Owner Service Advisory SA 08-03

SUBJECT: Release of Tornado Alley Turbo Service Bulletin TAT SB08-01

Service Bulletin

TAT SB08-01

Figure 1. Right side shown.
Left Side Similar.

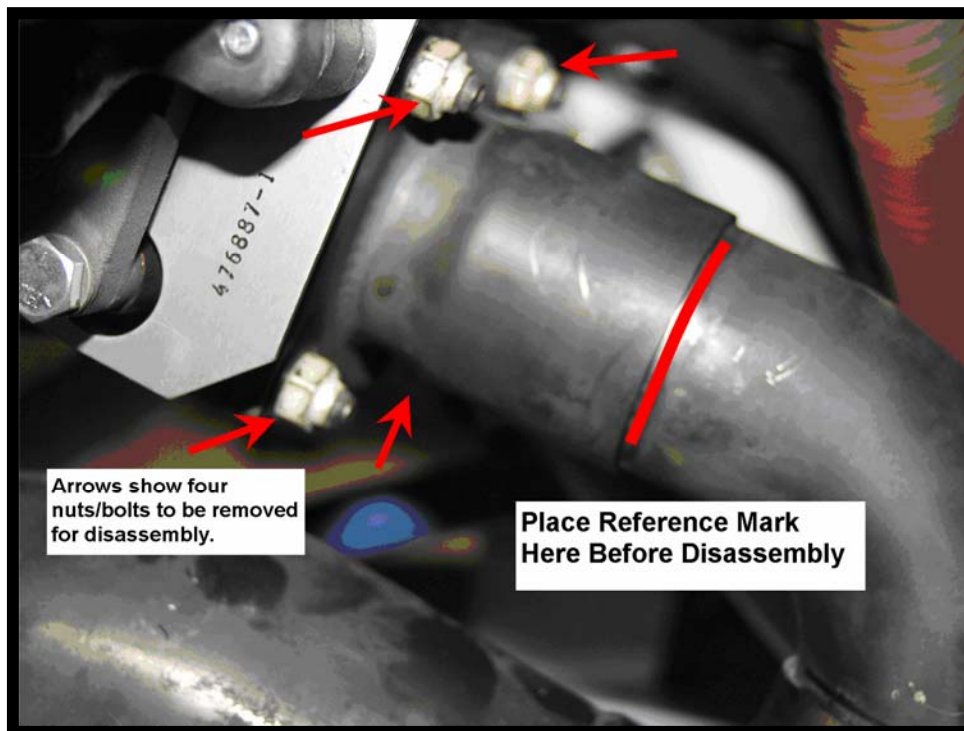
This Service Bulletin contains procedures to modify the right hand exhaust elbow (Group A) and both the right hand and the left hand exhaust elbow (Group B). This exhaust elbow is inserted between the tailpipe and the wastegate outlet fitting. See Figures 1 & 2.

- b. Visually locate the wastegate outlet on the aft side of the right hand wastegate. See Figure 1. Disconnect the heater hose clamp and hose from the intercooler to facilitate inspection and access.

- c. Visually inspect the right angle exhaust elbow and the area where the elbow inserts into the tailpipe, for any signs of a crack in the weld of the vertical receptacle in the tailpipe into which the short leg of the right angle elbow is inserted. If any cracks are observed, then contact Tornado Alley Turbo, Inc. for replacement parts before return to service or further flight.

- i. Measure the length of the elbow from the previously applied reference mark to the end of the long leg of the elbow.
 - j. If this measurement is greater than 1.00", shorten the elbow so that the engagement, when re-installed, will be no more than 1.10" and not less than 1.00" as measured from the reference mark.

- k. If the engagement length is less than 1.00" but is more than 0.90" then simply re-install the elbow. If the engagement is less than 0.90" then contact Tornado Alley Turbo, Inc., for a replacement elbow.

2. Re-install the elbow and the wastegate outlet assembly as follows:
 - a. Re-install wastegate outlet with the right angle exhaust elbow properly inserted into the wastegate outlet and the tailpipe.

- b. Loosely install the nuts on the four bolts.
 - c. Adjust the position of the wastegate outlet with the right angle elbow inserted into both the tailpipe and the wastegate outlet for a "nominal" fit with good alignment.

- d. Note: the wastegate outlet has slotted holes. Normally the slotted holes should be oriented so the wastegate outlet flange can be adjusted in-board and out-board. However, it is permissible to orient the wastegate outlet so that it can be adjusted vertically, if a better fit up is obtained.

- e. Torque nuts to 70 in-lbs.
3. Complete the aircraft records by noting compliance with Service Bulletin TAT SB08-01 in the aircraft logbook.
4. Return the completed "TAT SB08-01 Service Bulletin Information Sheet" and all replaced parts, if any, to Tornado Alley Turbo, Inc. for warranty credit.

Figure 2.
Left side.
Showing where to place reference mark before disassembly.

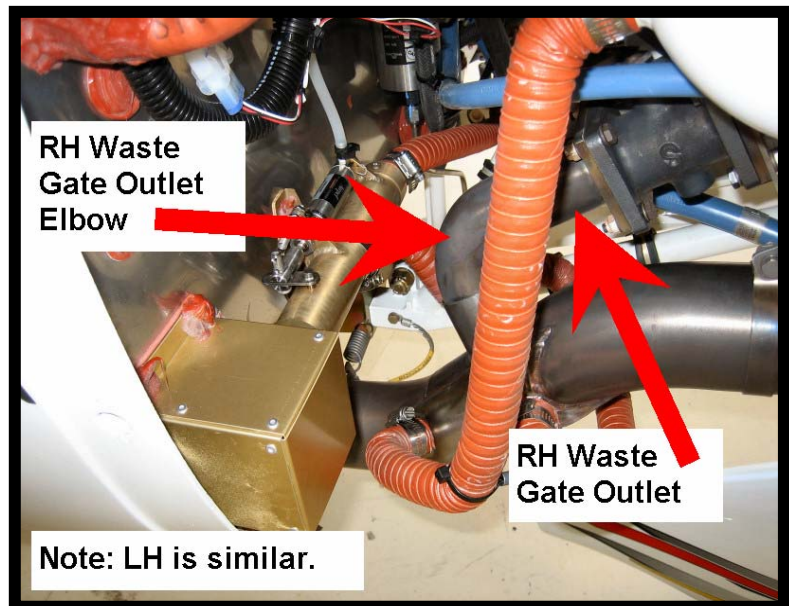
- d. Clean the area where the elbow is inserted into the wastegate outlet tube.
 - e. Mark the exhaust elbow at the aft end of the wastegate outlet tube.

- h. Remove the exhaust elbow from the wastegate outlet swaged tube and clean any exhaust residue from the elbow and wastegate outlet tube assembly. **Be careful to preserve the previously applied reference mark.**
